Intel® 80219 General Purpose PCI Processor

Specification Update

Document Number: **274020-002**

Figure 2. Intel® 80219 General Purpose PCI Processor P_BMI Signal Implementation for Intel® 80219 General Purpose PCI Processor B-0/B-1 Stepping

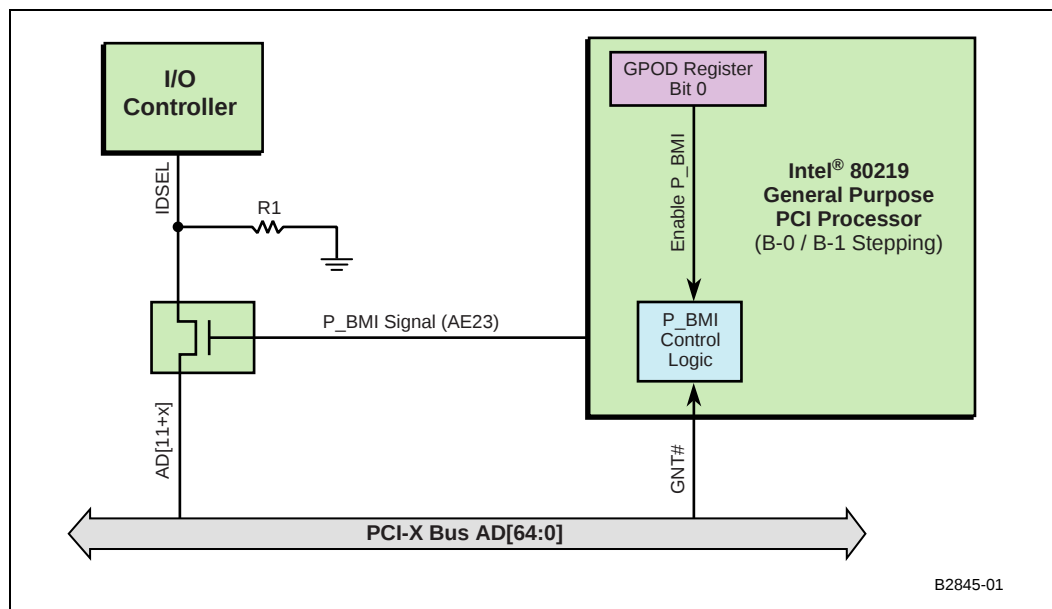
1. **Signal NC2 was renamed to P_BMI (AE23). New function added to signal P_BMI.**

The P_BMI (AE23) signal has been added to the Intel® 80219 general purpose PCI processor. This signal replaces, using an external GPIO pin for Initialization Device Select (IDSEL) control of an I/O device during host configuration cycles.

The 80219 has eight integrated General Purpose Input Output (GPIO) pins, referred to as GPIO[7:0]. These pins, along with the new PCI-X Bus Master Indicator (P_BMI) signal, can be used to control the IDSEL to the I/O device. External circuitry is no longer required other than a simple switch. The output function of the P_BMI signal is controlled by the GPIO Output Data Register (GPOD), Bit 0 as shown in Table 1. The P_BMI signal is always driven and defaults to driving low at power up.

The IDSEL signal is used as a chip select during configuration cycles initiated by the BIOS, operating system or 80219. The GPOD[0] can be driven low in firmware, thereby disabling the P_BMI signal and hiding the host I/O device from the system, by turning off its IDSEL. When the 80219 intends to perform configuration cycles in the PCI bus segment of the I/O device, the P_BMI signal should be asserted high by driving the GPOD[0] high. The affect of these two operations is, that the I/O device is initialized and controlled by the 80219. More care must be taken with the gate chosen to control IDSEL, since most host bridge controllers do not use PCI address stepping. With IDSEL being a synchronous signal, with respect to CLK, the switch used must be a sub nanosecond propagation delay device (e.g., Pericom PI5C3303). In Figure 2, the P_BMI signal is used to control a MUX/DeMUX switch that is used to enable/disable IDSEL to the I/O device.

Note: The host BIOS does not require any modifications to accommodate this implementation. All the responsibility for I/O device configuration and resource falls to the 80219 firmware.
